Minnesota Pollution Control Agency

RE: Minnesota Pollution Control Agency Response to the Vapor Intrusion Pathway Investigation Report for the General Mills/Henkel Corporation Site; Site ID#: SR3

The Minnesota Pollution Control Agency (MPCA) completed review of the Vapor Intrusion Pathway Investigation Report (Report) prepared by Barr Engineering Company (Barr) for General Mills, Inc. (GMI) dated July 2015 for the General Mills/Henkel Corporation Site (Site).

Specific MPCA review comments for: Vapor Intrusion Pathway Investigation Report, East Hennepin Avenue Site, Minneapolis, Minnesota. Prepared for General Mills, Inc. By: Barr Engineering Co.

**Figure 1 – TCE Groundwater Concentrations in the Shallow Glacial Drift
March 2015 Sampling Event**

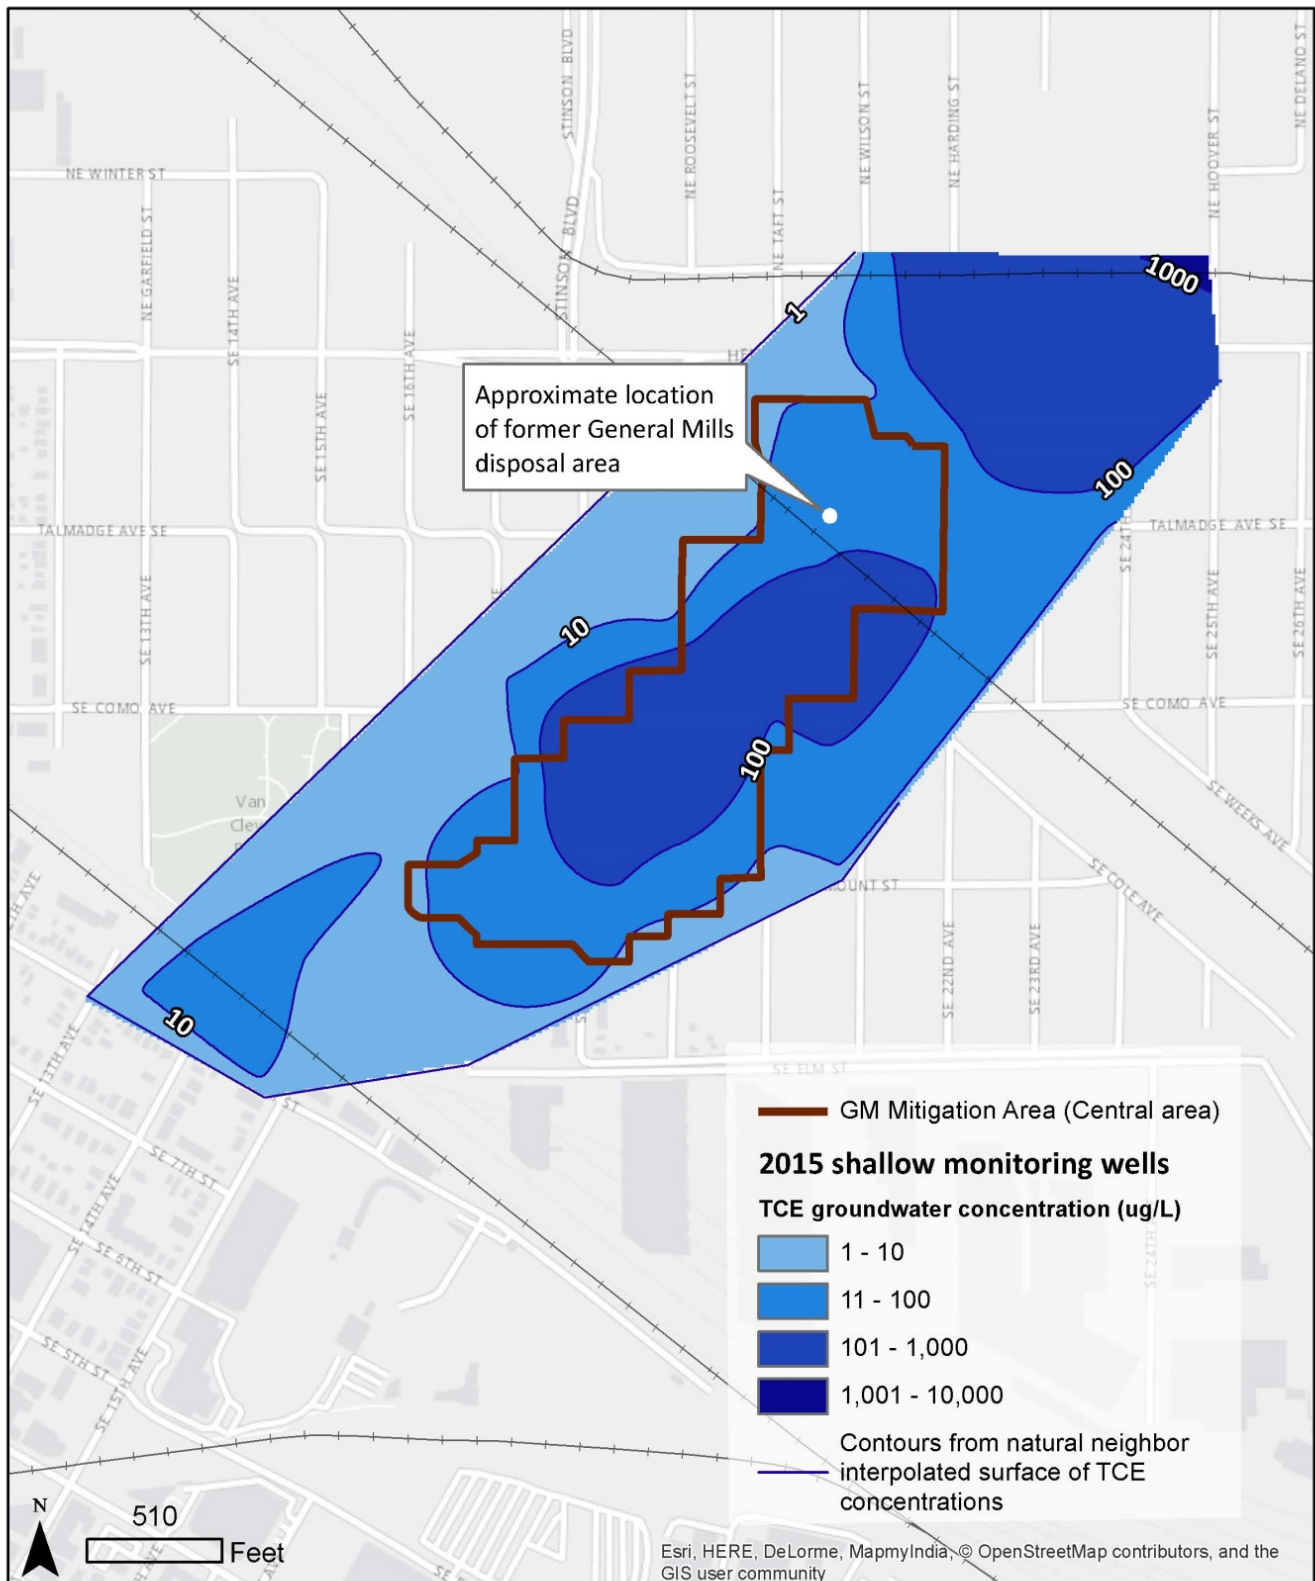
The groundwater plume in the shallow glacial drift is a primary source of trichloroethylene (TCE) vapors identified beneath residential homes and commercial buildings in the area. MPCA acknowledges, and has started investigating, multiple potential release sources of TCE that may be contributing to an area-wide groundwater contaminant plume in the vicinity of the Site. However, Report data indicates that the GMI release is a primary source of TCE contamination in the area. Figure 1 (attached) illustrates TCE concentrations in the shallow glacial drift for the March 2015 groundwater sampling completed by GMI. As shown on Figure 1, elevated (>100 $\mu\text{g/L}$) TCE concentrations in the shallow glacial drift up-gradient (northeast) of the Site do not extend onto the Site or into the central area investigated by GMI. An area of elevated TCE in groundwater is present in the shallow glacial drift directly down-gradient (southwest) of the Site in the central area consistent with a TCE release from the Site.

Figure 1 shows TCE groundwater contours generated from GMI's sampling of shallow permanent monitoring wells in March 2015.
